Subject: Approval for Castle Valley Mining #2 Belt Access Road

Castle Valley Mining in Huntington, Utah would like to submit for approval an access road to an area known to the mine as #2 Belt. Attached plate's 2-2B, 5-2F, and 7-1F included in this submittal showing the area constructed.

**Title:** Access Road #2 Belt for Castle Valley Mining, Bear Canyon Mine, C/015/0025, Emery County, Utah

BEAR CANYON PLATE 2-2B

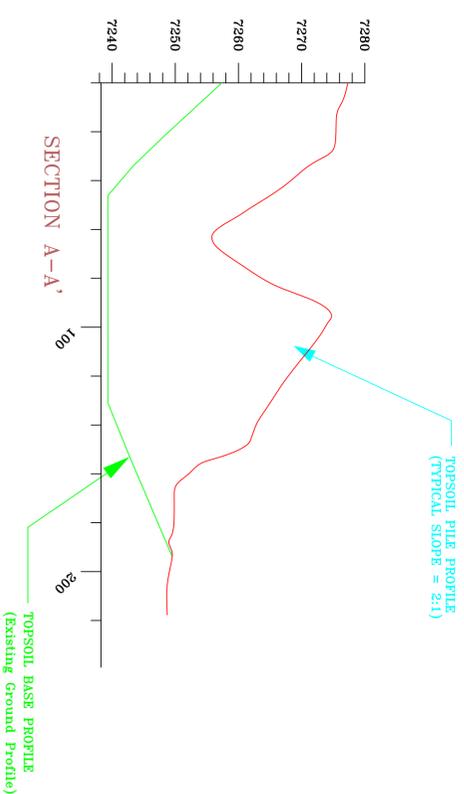
REV.	DATE	REMARKS	APPR.
1	6/01/02	Changed name from plate 2-7 to 2-2B.	12/9/06
2	5/09/16	Revised topsoil pile & road	
3			
4			
5			
6			
7			
8			
9			
10

BEAR CANYON PLATE 5-2F

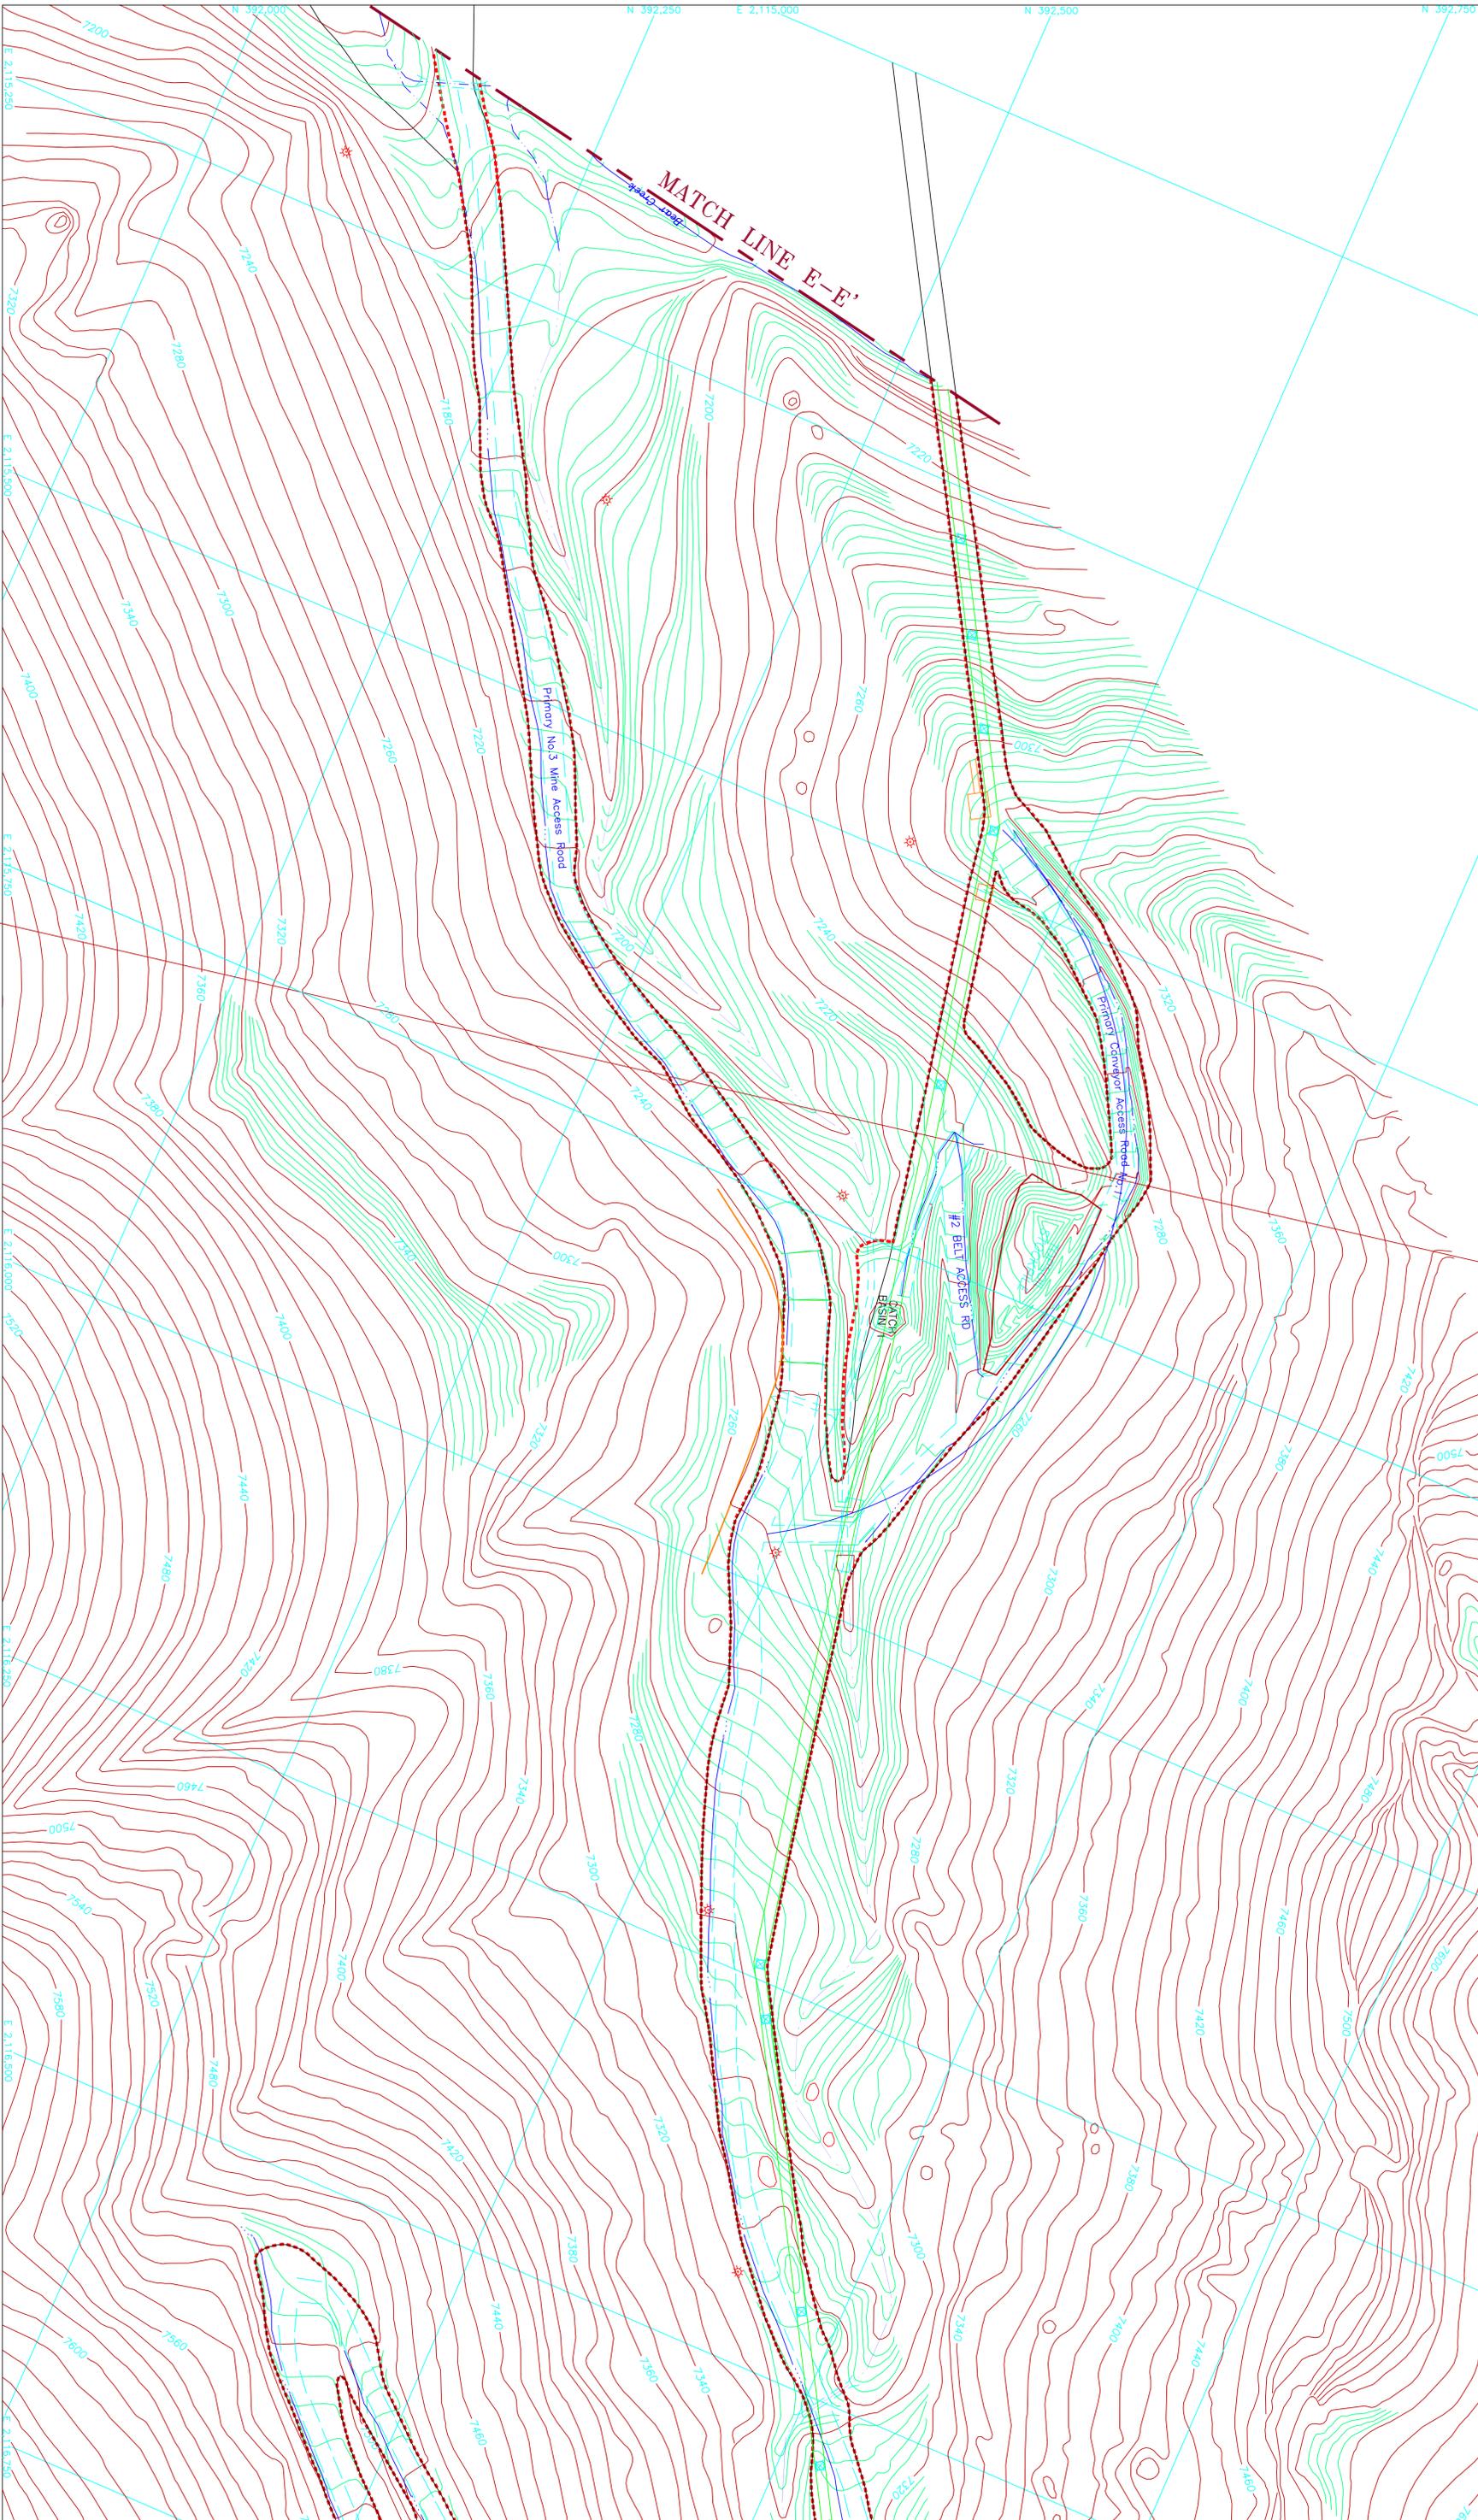
REV.	DATE	REMARKS	APPR.
1	6/25/01	WHR surface facilities added (S198-1)	7/03/01
2	8/01/02	Changed name from 2-4F to 5-2F	12/8/05
3	5/09/16	Revised topsoil pile & road	
4			
5			
6			
7			
8			
9			
10
